JAZZHOUSE

8.0 EDG SUMMARY

8.0 ITEMIZED RESPONSE TO EDG

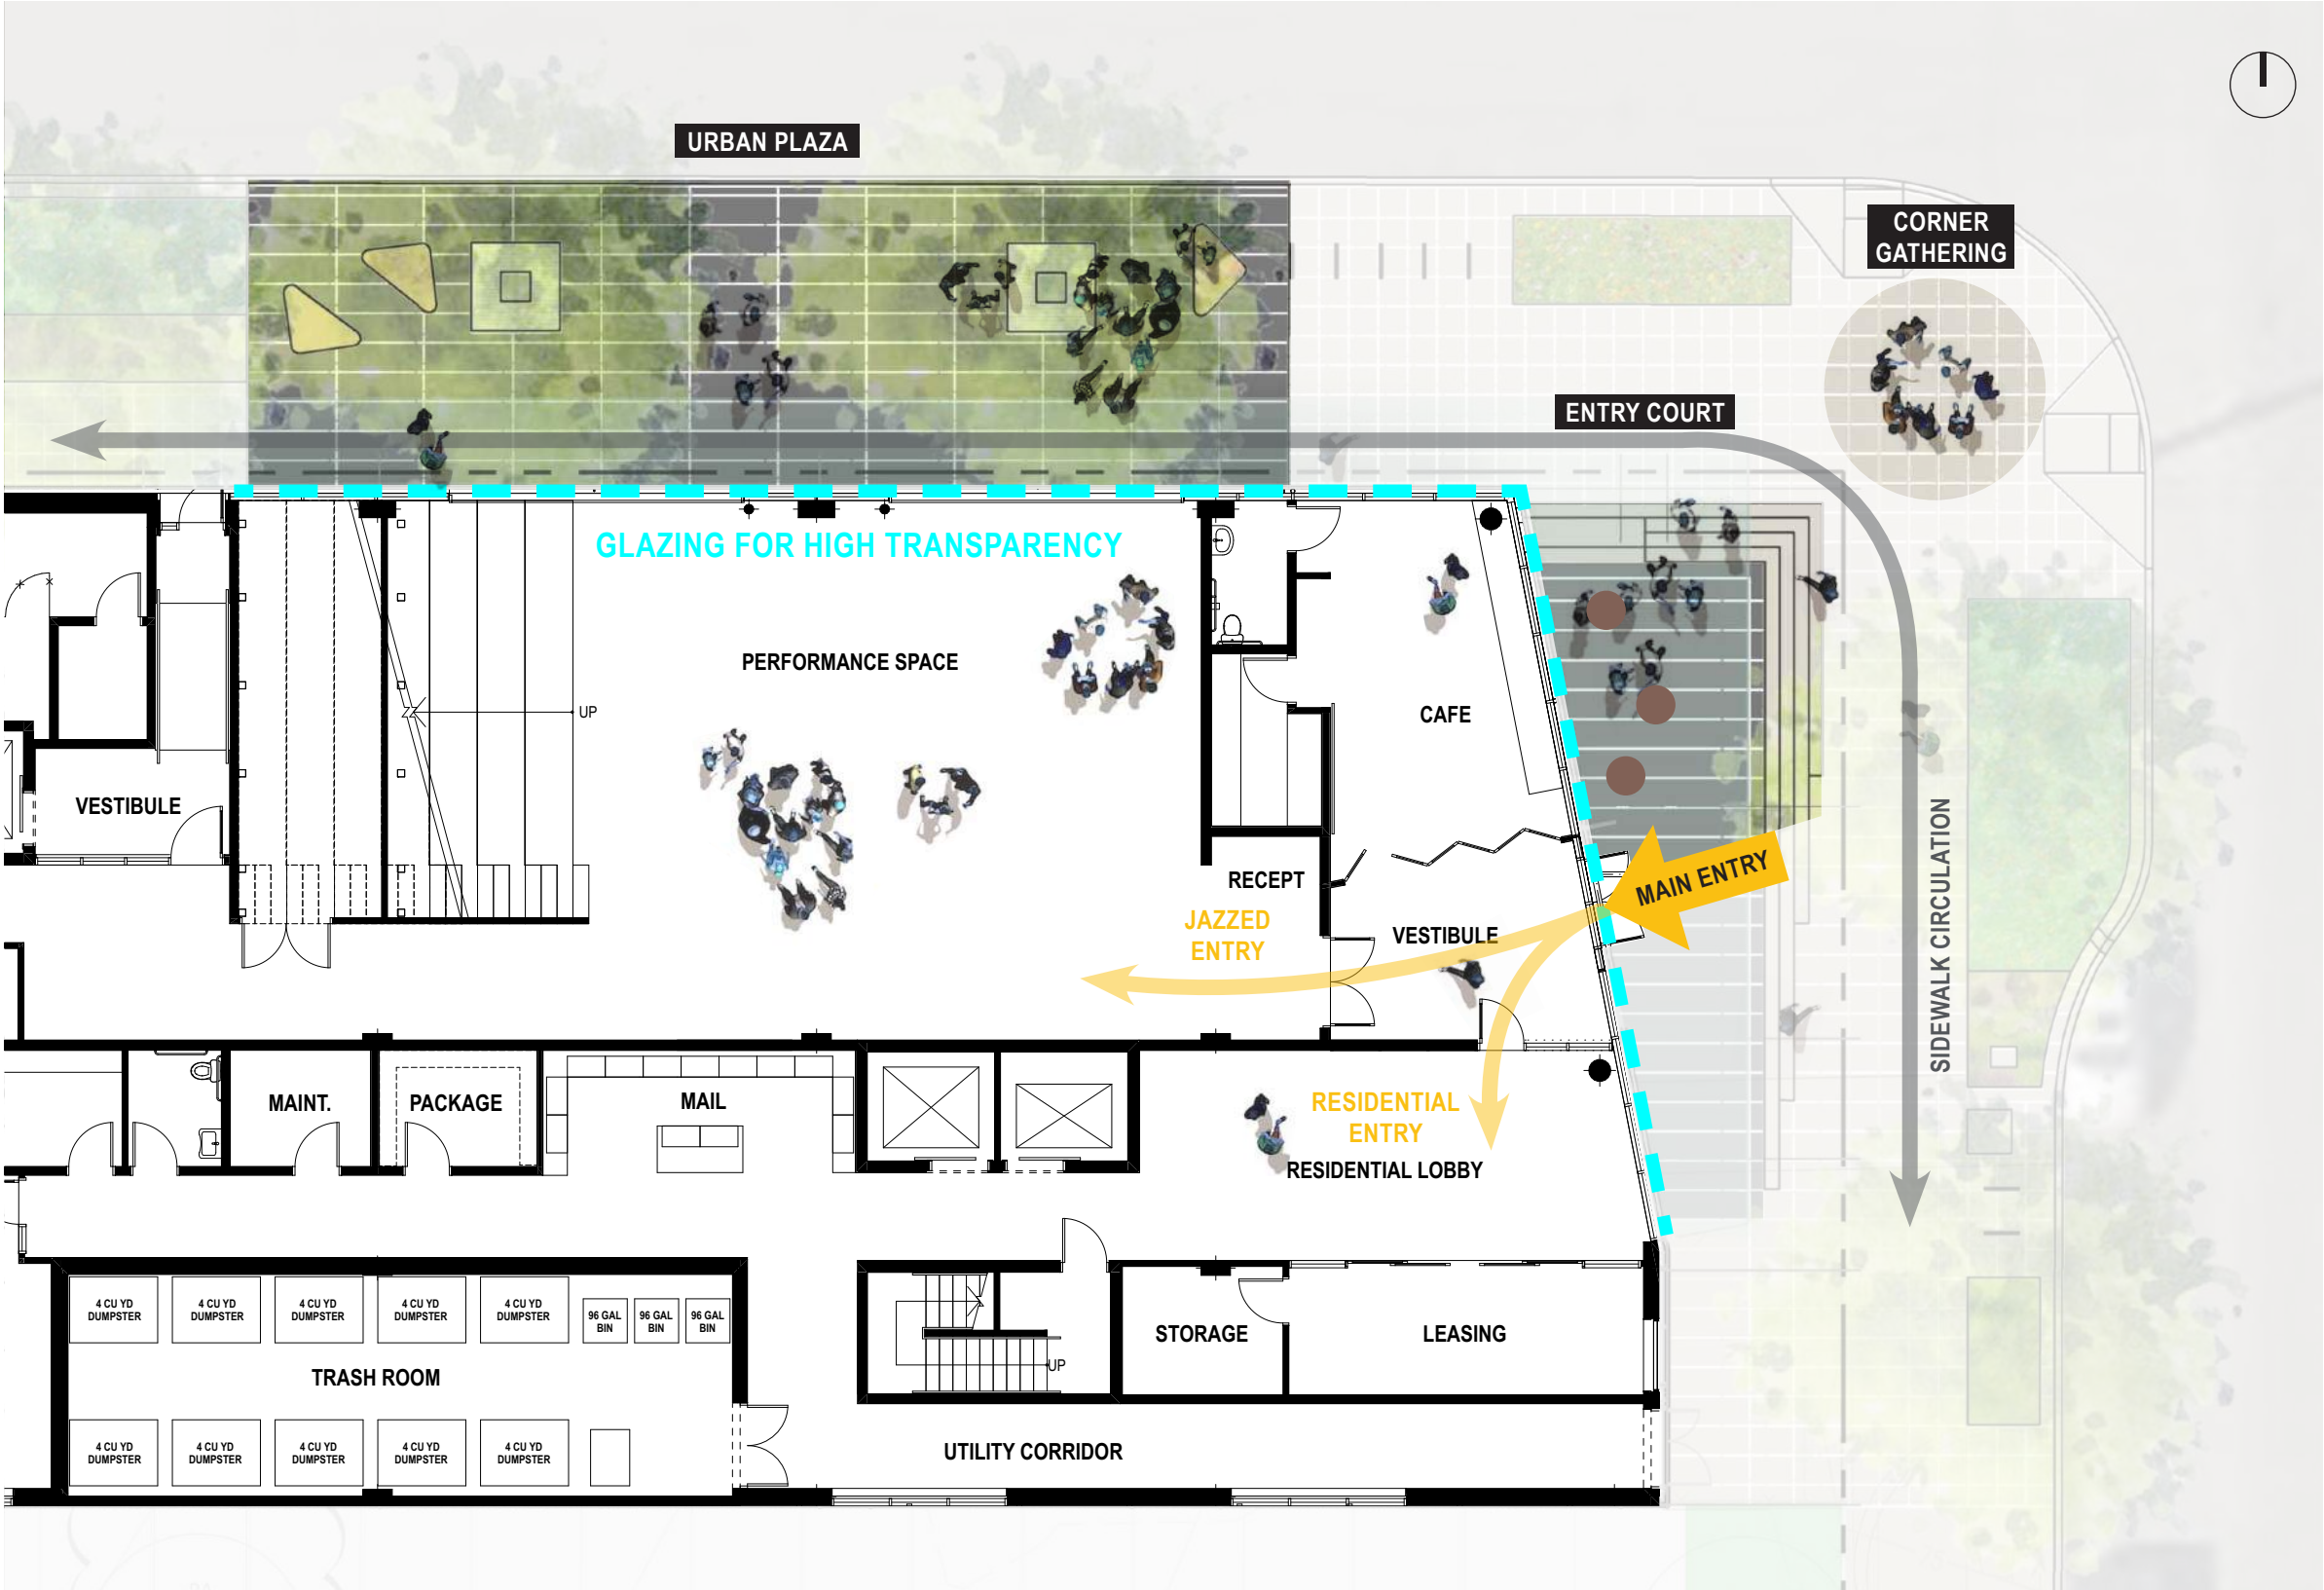
2d d) Staff supports the design of the northeast corner that has been carved away to accommodate a focal point for the main building entry and an entry plaza that is connected to a commercial retail space proposed as a café. Staff sees this as a gateway opportunity that will require careful detailing due to its high visibility from the street. Staff requests additional studies demonstrating how the plaza, the retail space, and their relationship to both the residential and school entries will function. (CS2-B, CS2-C-1, PL3-A-2, DC2-C)

Response: The collaboration between Community Roots Housing and Seattle JazzEd and the future building community is celebrated through one primary entrance identified by carving away the building massing, providing a grand canopy, and elevating an entry court. As such, all community members are equally welcomed into the space through the single front door before diverging into the respective destination. The actual entry door is offset from the entry court to provide equitable accessibility to the entrance and optimize the usable, outdoor space of the elevated court – primary circulation occurs central to the east façade while the court may be occupied to the northeast of the main entrance.

Additionally, the material details are carefully considered. A blackened metal canopy with a warm wood ceiling is designed with rhythmic coffers to reduce the scale. Integral soffit lighting and blade signs will be provided.

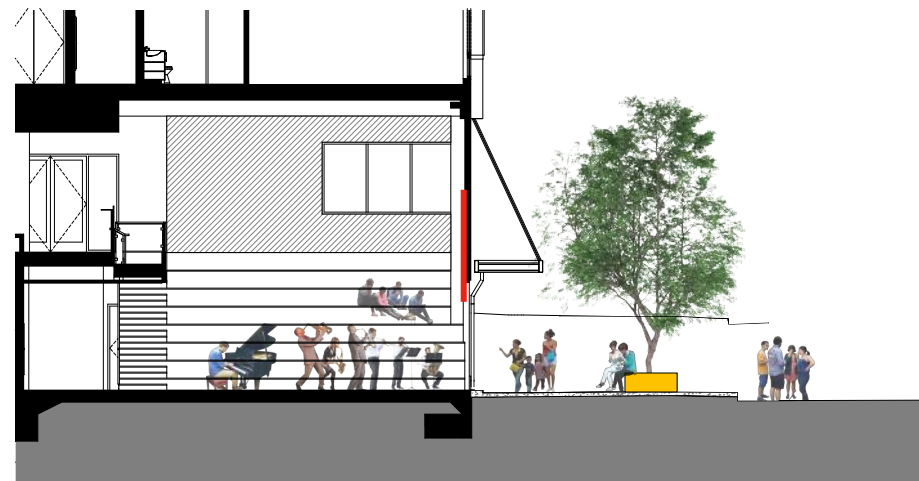
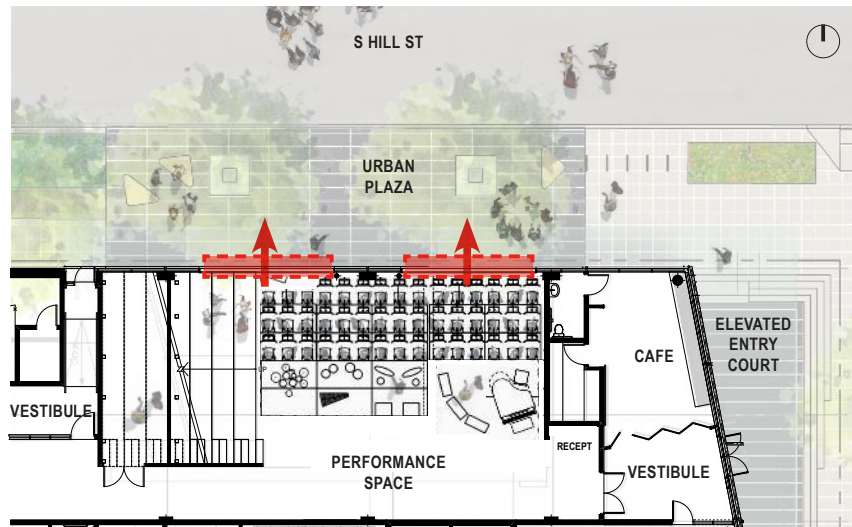
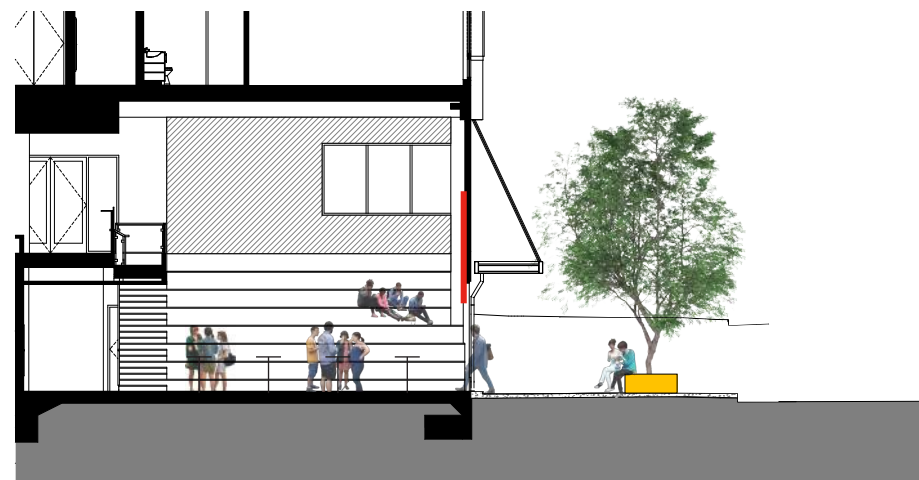
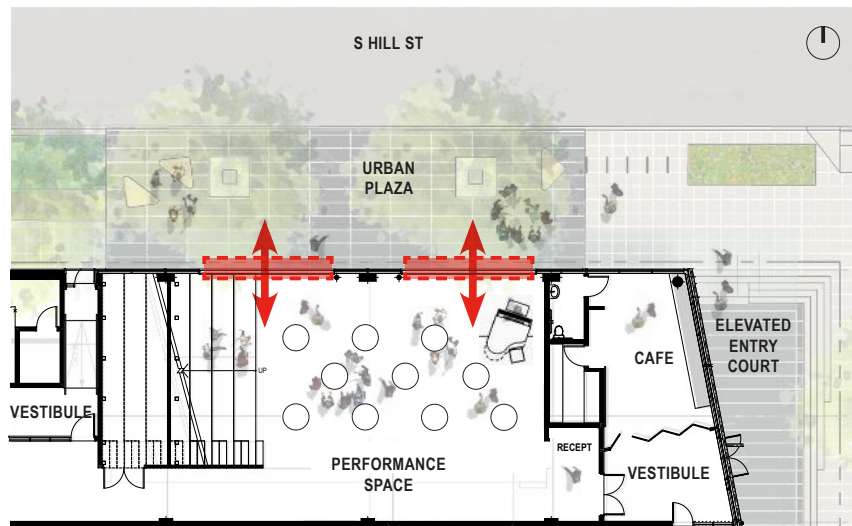
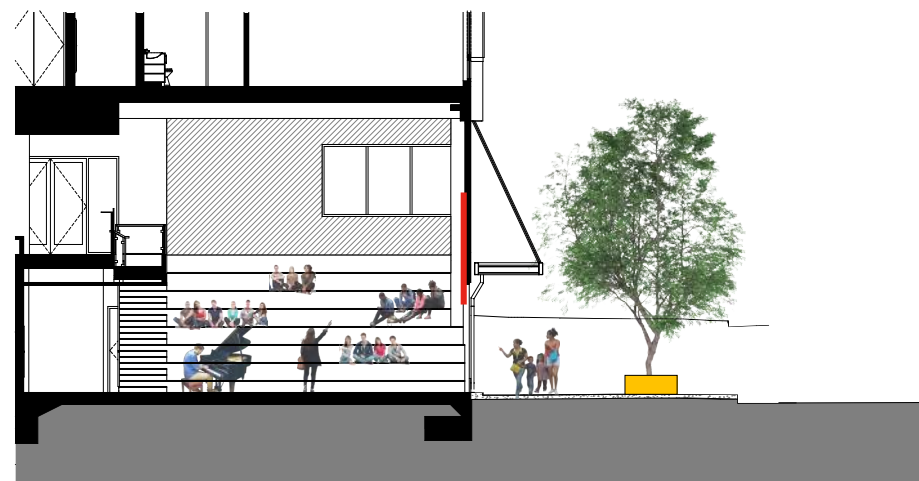
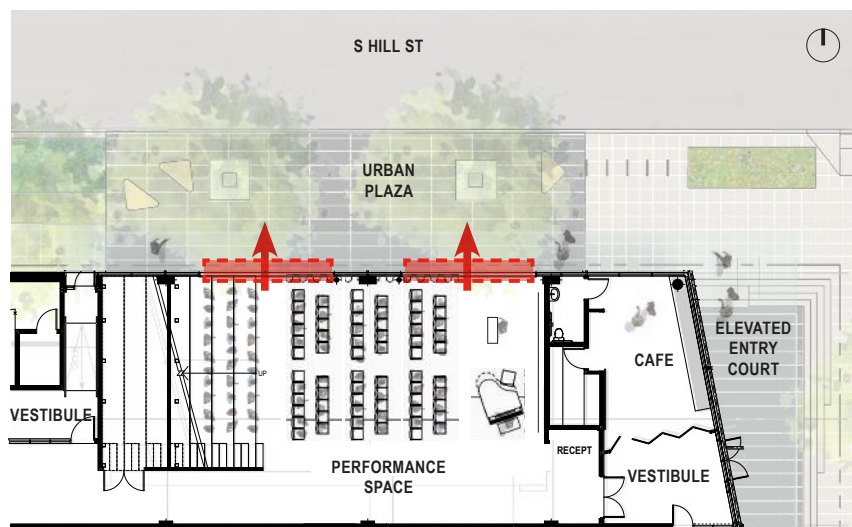
- 2e** e) Staff supports the concept for the urban plaza and its use as a spill out area during musical performances and other activity. The design team shall provide additional vignettes with the MUP application, depicting how indoor activities will spill out into the 'public plaza area. As an advisory note, the design team will need to obtain the necessary approvals from all City agencies. (CS2-B-2, CS2-C-1, CS3-A2, PL3-A-1, DC2-E)

Response: Seattle JazzEd has secured street use permits to host block parties on S Hill St in the past and will continue to do so with the next one planned for late-summer 2021. The multifunctional performance space is designed with garage doors allowing for the space to function as a stage to the block, a circulation route during events, or operable fenestration to provide visual and audible connection with the public realm.

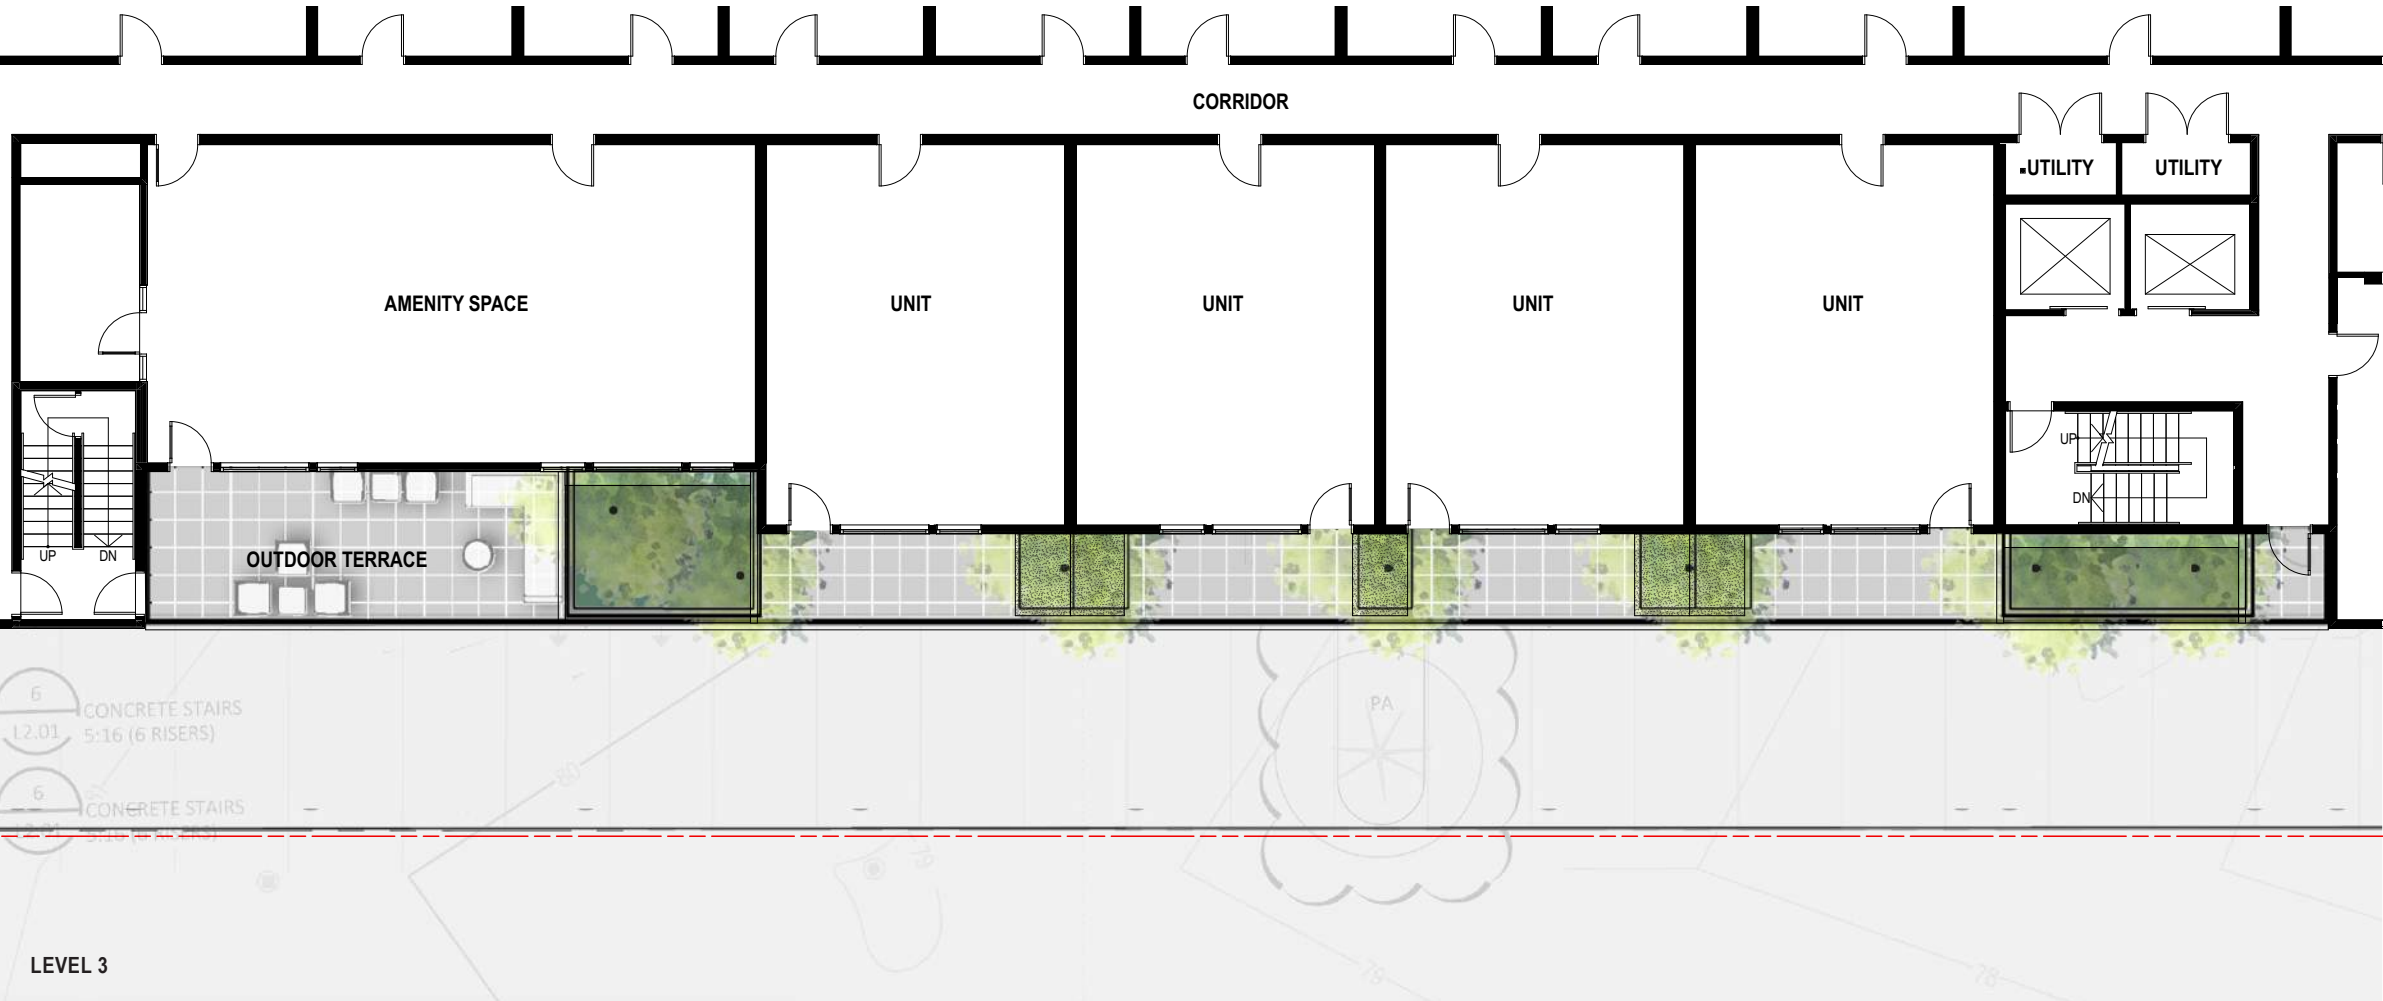
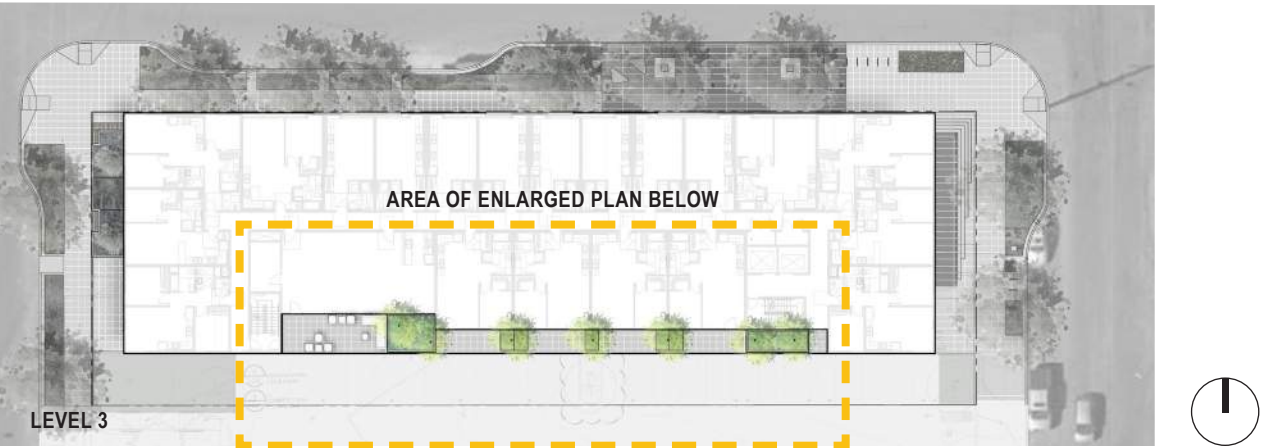
2f f) Staff supports the creation of the south facing outdoor amenity space but requests additional information on how the space will be used and whether it's intended for individual or public use. (CS2-B, CS2-C-1, PL3-A-2, DC2-C)

Response: The third-floor terrace is intended for residential use only. Raised, movable planters with plantings separate the southern unit private patios, while a bioretention planter screens the shared outdoor residential amenity space (adjacent to the residential amenity room) from the units. The shared outdoor residential amenity space is intended to be used as an extension to the indoor space.
